**CHARTER TOWNSHIP OF VAN BUREN
PLANNING COMMISSION AGENDA
Wednesday, March 13, 2019 – 7:30 PM
Van Buren Township Hall
46425 Tyler Road**

ITEM #1: Case 19-001 – PRELIMINARY SITE PLAN APPROVAL - PROJECT SYCAMORE

**Subject: VBT-19-001; Project Sycamore; 9000 Haggerty Road; Preliminary Site Plan Review #2
Revised Site Plans Dated February 22, 2019.**

Re: Sycamore Project
9000 Haggerty Road
Final Site Plan Review

C-2004

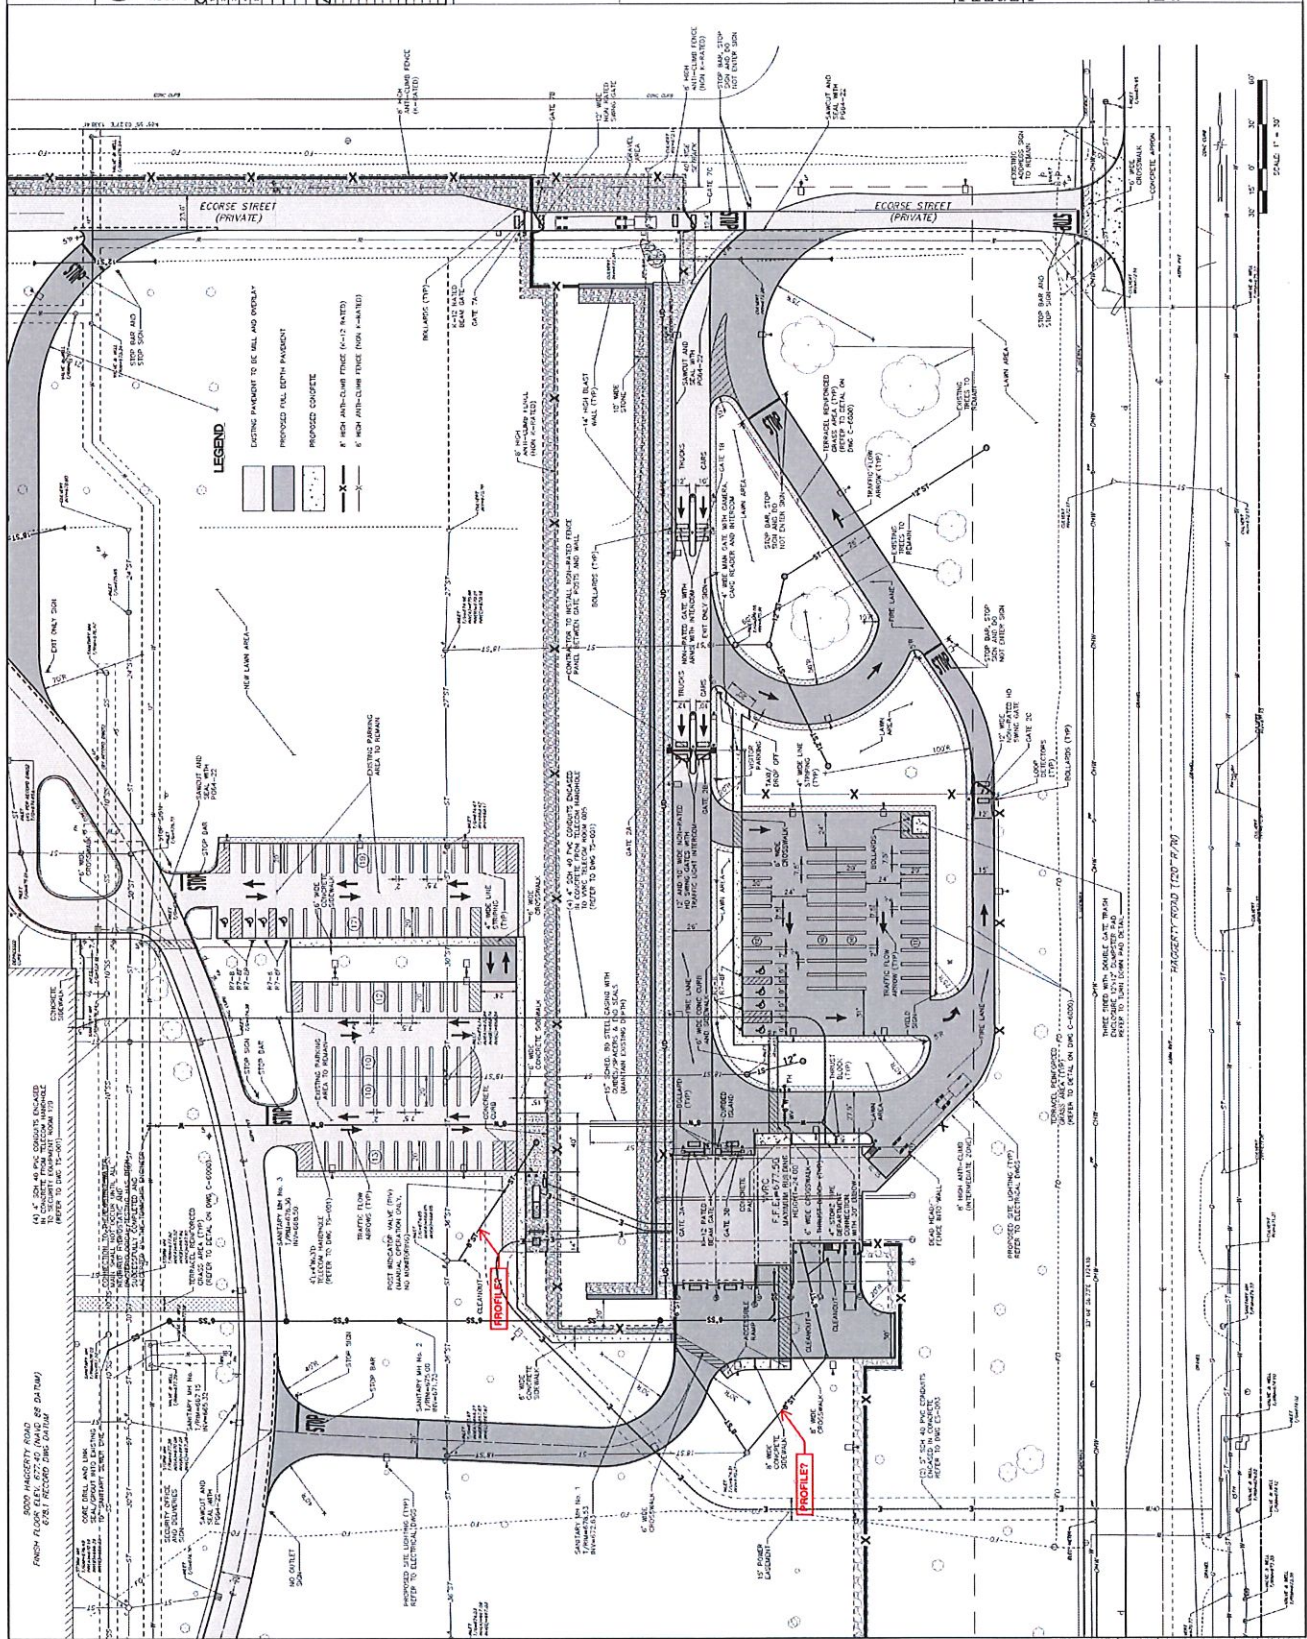
- ~~3. Dead end fire department access roads in excess of 150ft. in length shall be provided with approved provisions for fire apparatus to turn around. Loop access between parking lots is requested to accommodate requirements and provide access to current and future buildings proposed.~~

4. ~~Sliding gate access, how does the company plan on allowing access to fire department?~~
5. ~~Building construction and use is needed to identify, suppression requirements and subsequent placement of hydrants and fire department connections. FDC connection shown on plans and placement ok with AHJ.~~

6. ~~How will fire department have access to future vehicle evaluation area listed on plans?~~
7. ~~Vehicle evaluation area building, use and construction, will determine hydrant and FDC locations around that building as well.~~
FDC will be placed within 50ft of hydrant on South side of building per phone call on 9-6-2018
